Proposed visitor hub,
Pontneddfechan,
Neath

Road Safety Audit - Stage 3

Table ID Project Details	
Report title	Proposed visitor hub, Waterfall Country, Pontneddfechan, Neath
Date	10 July 2026
Document ref.	26047d1
On behalf of	Andrew Scott Ltd

Location High Street at the north-east corner of the Angel Inn.

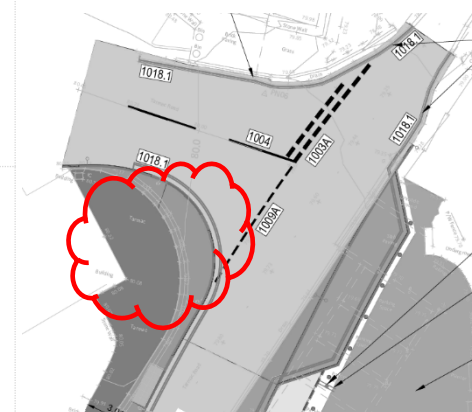
2.1.1 Summary Changes to the kerblines on High Street have created a (fairly) large expanse of black top adjacent to the Angel Inn (opposite the entrance to the waterfalls). This could encourage vehicles to park on the footway, increasing the potential for pedestrians to be hit by vehicles manoeuvring onto/off the footway.

It was noted from the site visit that the changes to the kerblines on High Street have created a (fairly) large expanse of black top adjacent to the Angel Inn (opposite the entrance to the waterfalls). This could encourage vehicles to park on the footway, particularly during very busy periods, increasing the potential for pedestrians to be hit by vehicles using the dropped kerbs manoeuvring onto/off the footway.

It is recommended that planters, benches or bollards are provided on the footway to prevent vehicle parking.

Location Proposed informal crossing across Pontneddfechan Road

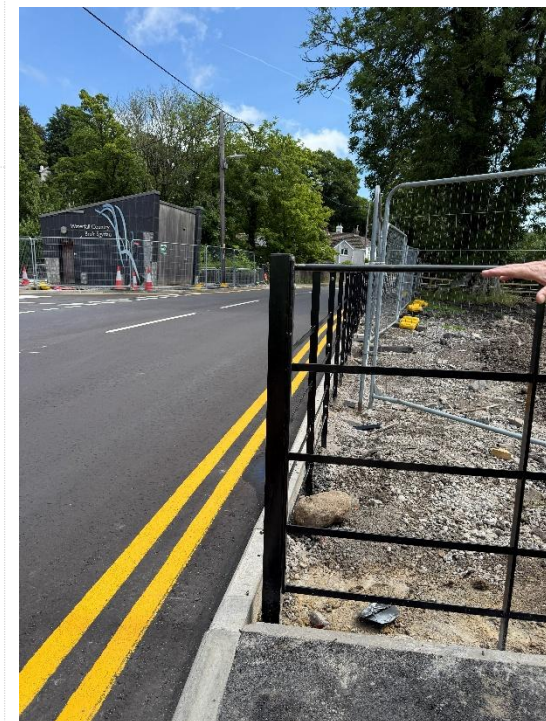
2.2.1 Summary Visibility for pedestrians waiting to cross the (informal) crossing (travelling south to north) is obstructed by the post and rail fence around the landscaped area to the east of the crossing and could lead to pedestrians stepping into the carriageway injudiciously.

It was noted from the site visit the visibility (to the east/right) for pedestrians waiting to cross the (informal) crossing (travelling south to north) is obstructed by the post and rail fence around the landscaped area to the east of the crossing. This could lead to pedestrians, particularly young children, stepping into the carriageway injudiciously.

It was also considered that an informal crossing in this location, leading to a car park with 150 parking spaces, was not adequate for the anticipated pedestrian demand crossing between the visitor centre and the falls.

It is recommended that either:

- (a) the post and rail fence is set back up to 1.5m from the kerb-edge and the strip between the kerb edge and the fence is replaced with hard surfacing (tarmac or block paving).
- (b) the crossing is upgraded to a standard zebra crossing.

The Audit Team, Police and Local Highway Authority did consider the provision of a simple zebra crossing at this location, which doesn't require either Belisha Beacons or zig-zag road markings. However, in accordance with the Traffic Signs and General Directions (TSRGD) for Wales (11th March 2026), a compact **side-road** crossing is only permitted where:

(a) The crossing is within 5m of the give-way line at the mouth of a minor road; (b) Both the main road and side roads have a 20mph speed limit; and, (c) The crossing is installed directly across the pedestrian 'desire-line' at the junction.
